APPLICATION
WITHDRAWN

CASE FILE #PL201800255

PORTILLO'S HOT DOGS
BLOOMINGTON, MN

SITE ARIAL
PLAN

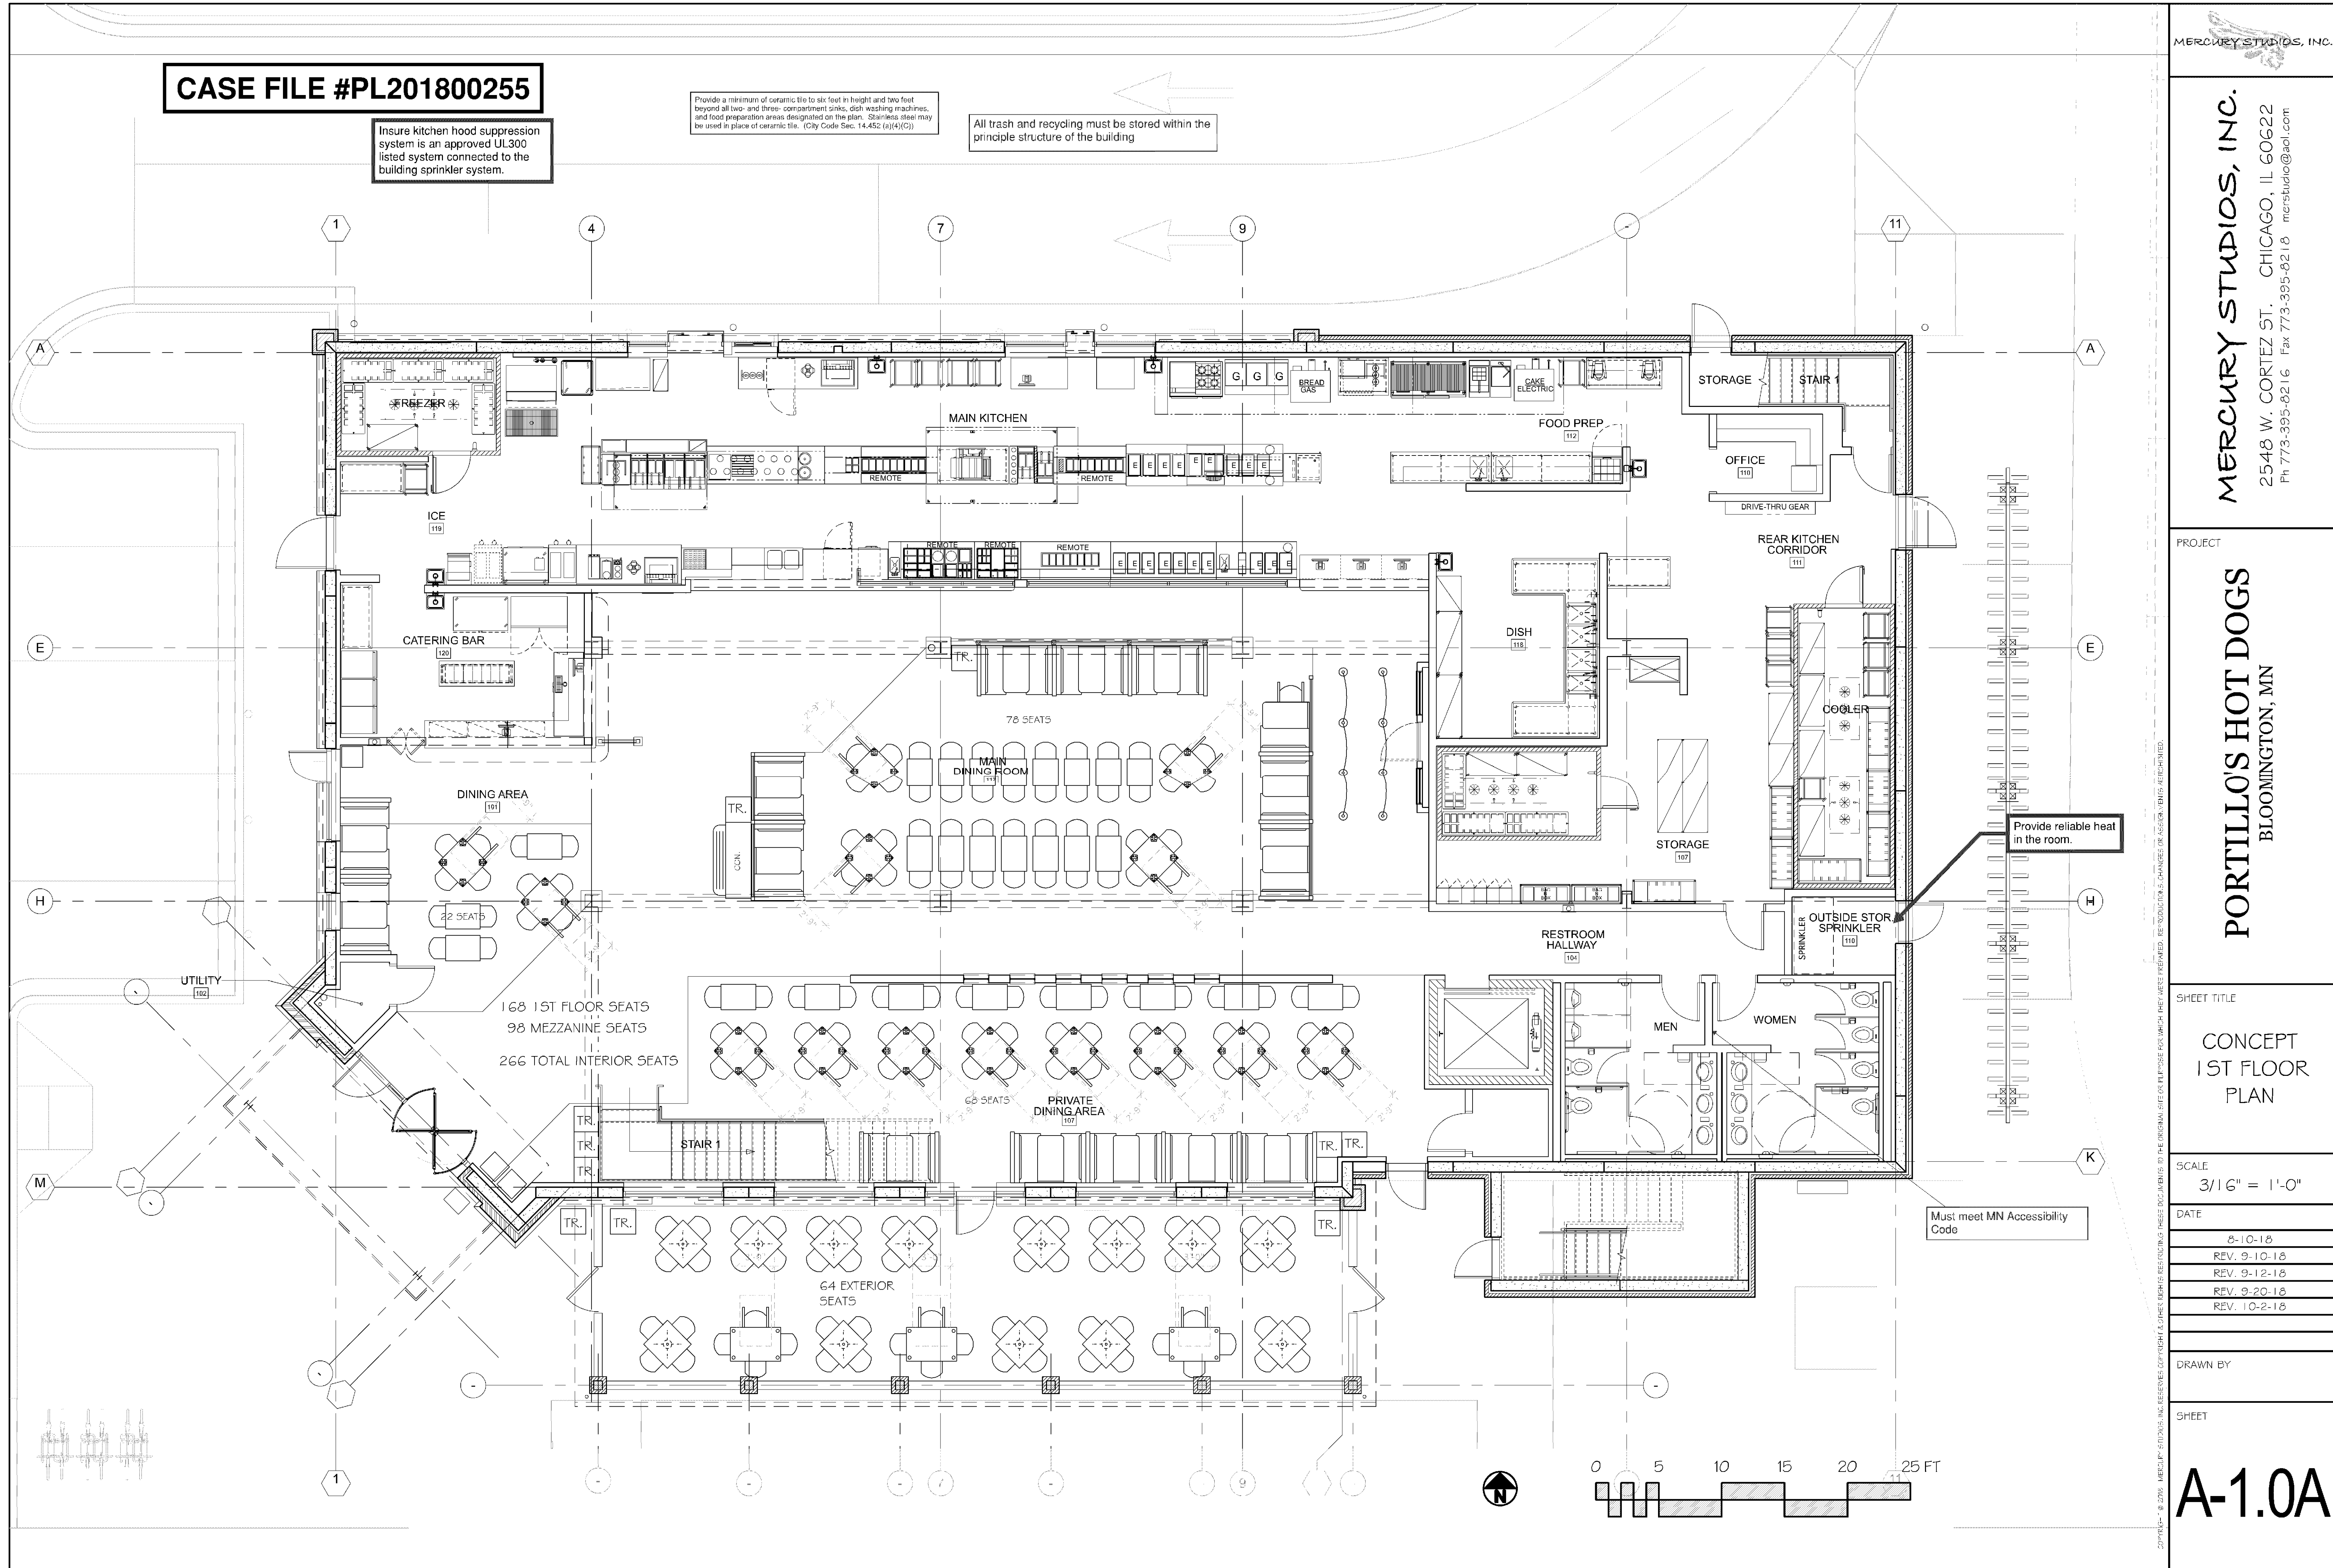
Hydrant coverage shall be provided within 50' of the FDC and within 150' of all portions of the structure.

Emergency responder radio coverage meeting the requirements of appendix L in the 2015 MSFC shall be provided throughout the property and within the structures.

Provide emergency vehicle access around the structure and adequate turning radius to accommodate BFD Ladder 1

CONCEPT
1ST FLOOR
PLAN

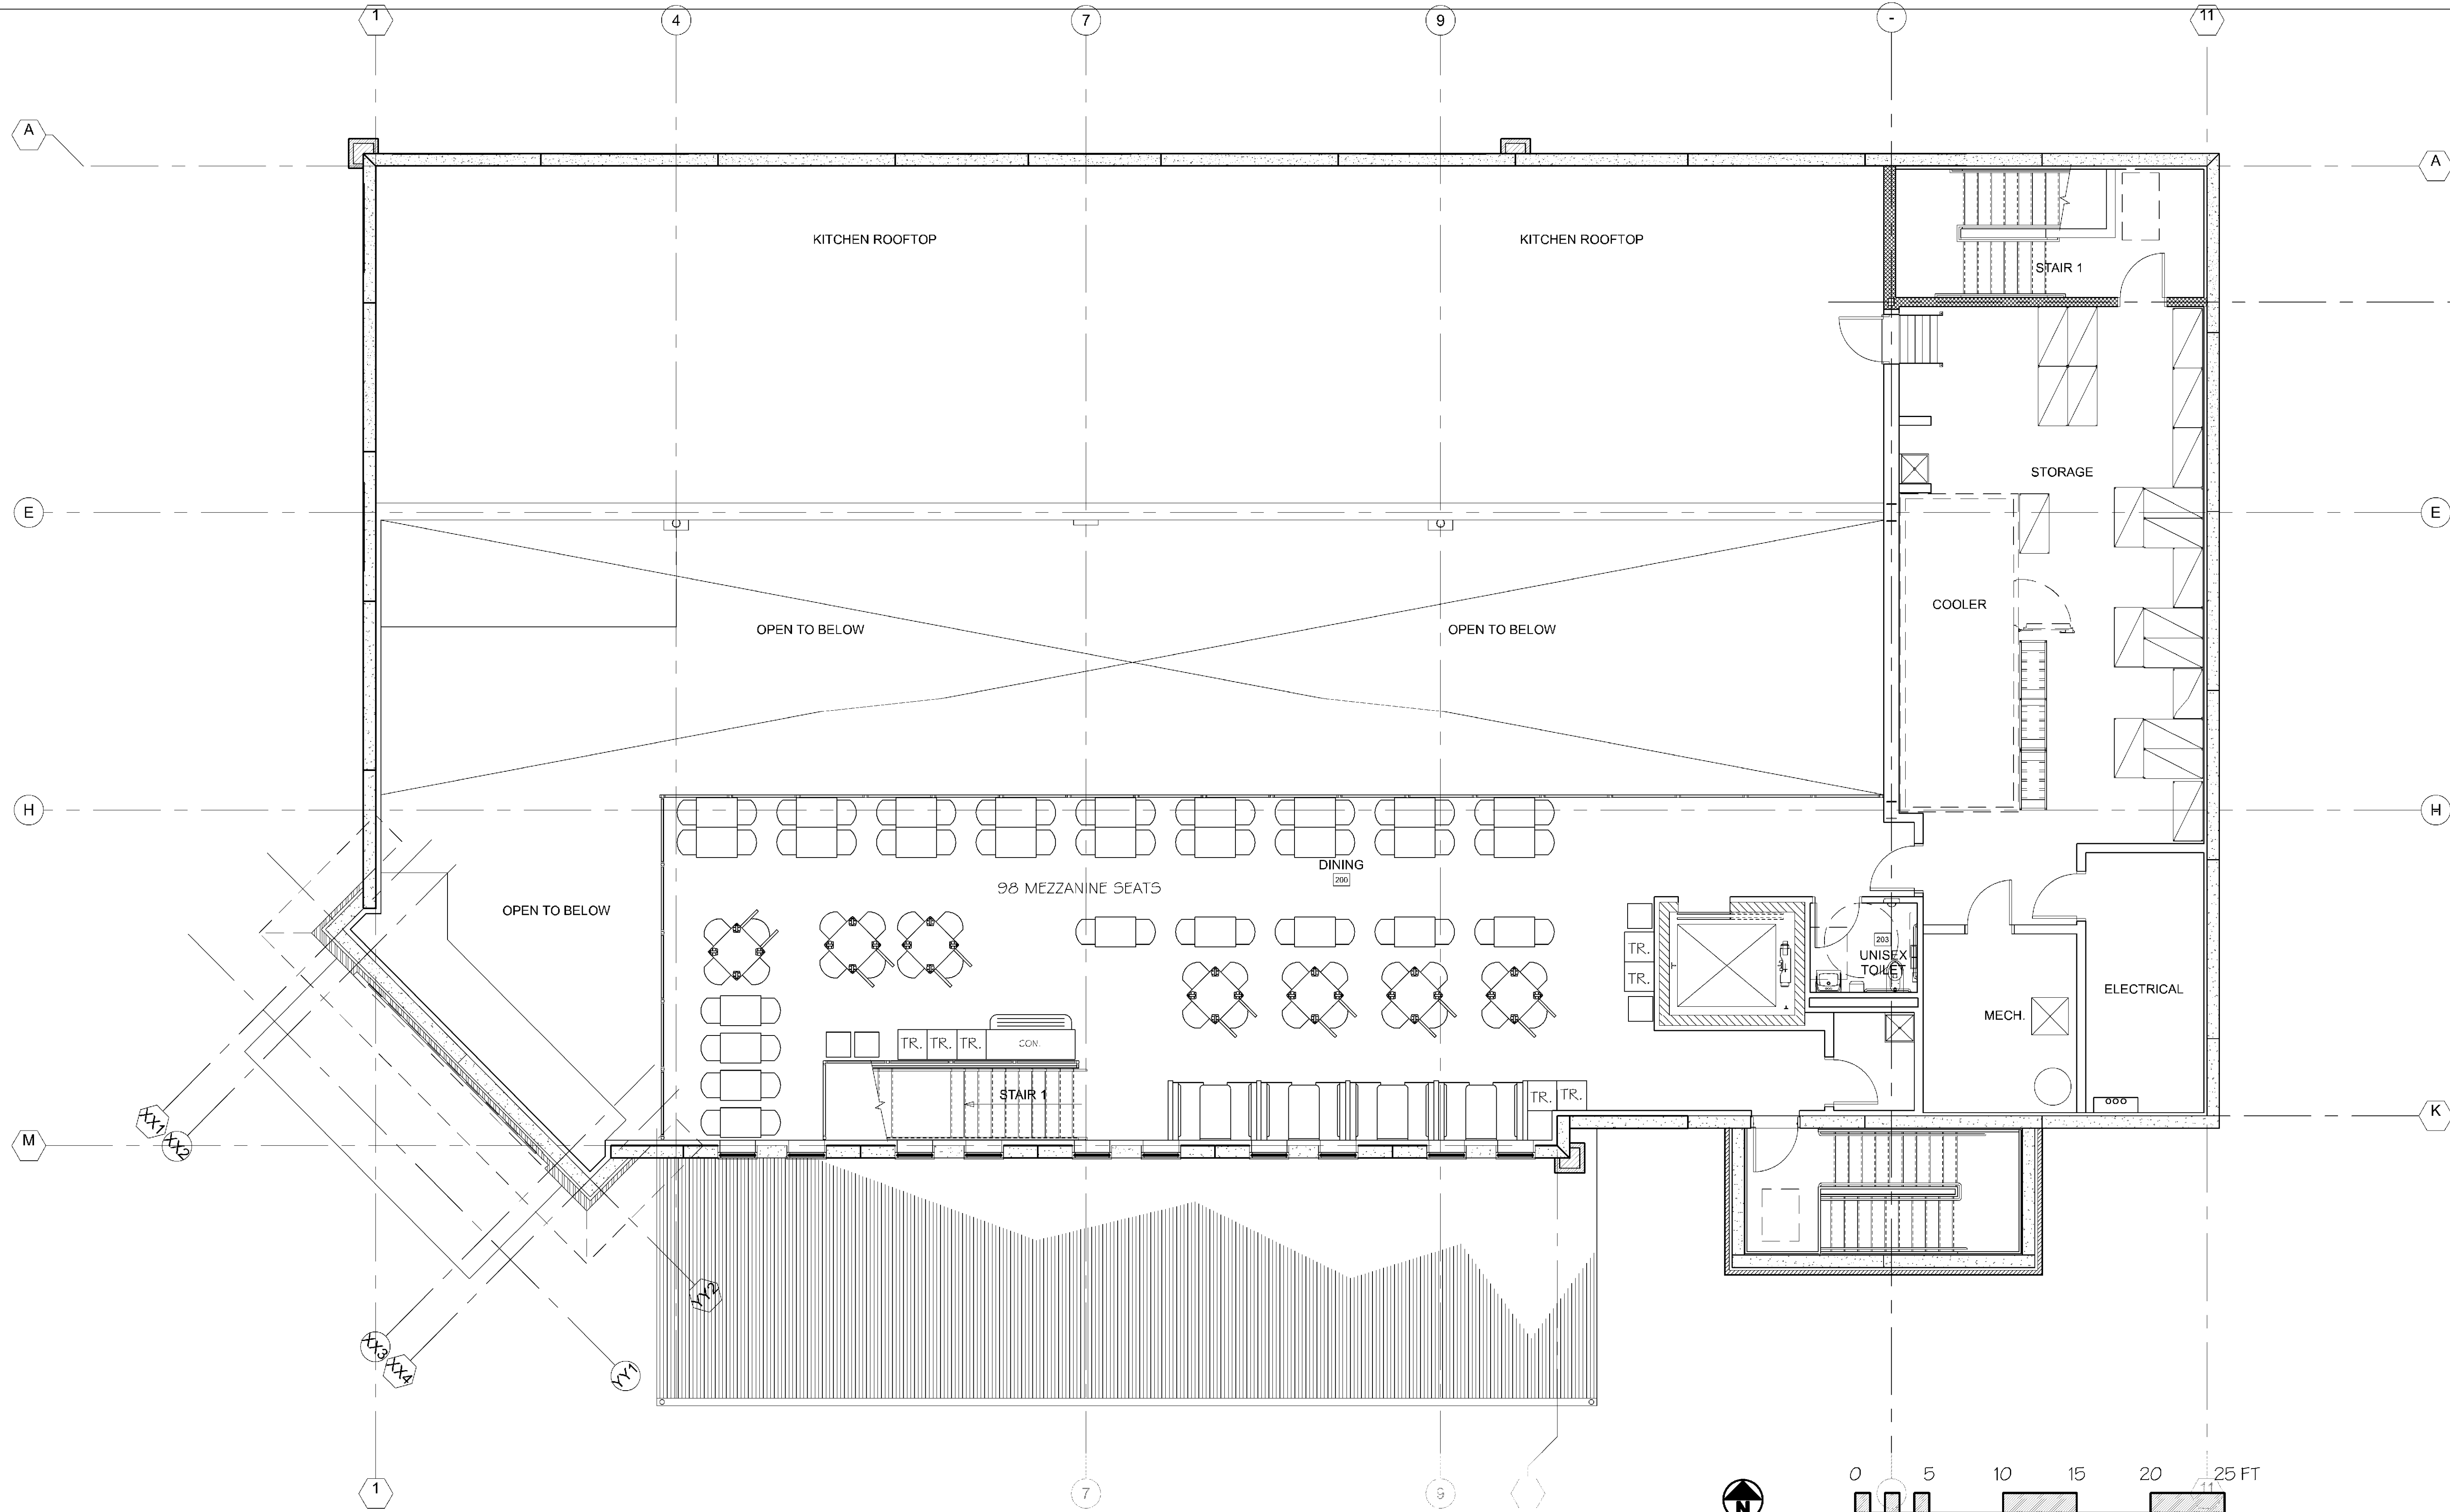
Insure kitchen hood suppression system is an approved UL300 listed system connected to the building sprinkler system.

Provide a minimum of ceramic tile to six feet in height and two feet beyond all two- and three- compartment sinks, dish washing machines, and food preparation areas designated on the plan. Stainless steel may be used in place of ceramic tile. (City Code Sec. 14.45c (a)(4)(C))

All trash and recycling must be stored within the principle structure of the building

Provide reliable heat in the room.

Must meet MN Accessibility Code
